Center Hall Remodel Questions & Answers

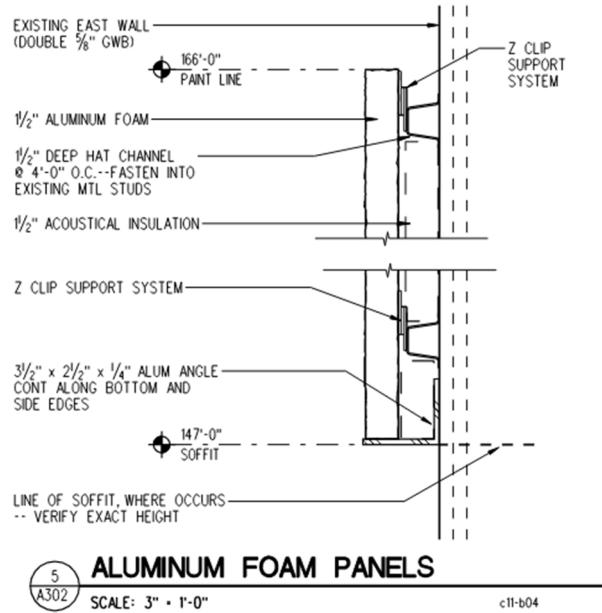
Question: *Is there any mechanical, HVAC or fire system work included in this project?*

Answer: The scope of mechanical and fire protection work for this project is minimal. The new ceiling at the entry portals will consist of an open metal slat system located at the plenum space. Existing fire sprinklers and smoke detectors will require relocation and replacement with concealed heads. Refer to Detail 2/A551 for additional information.
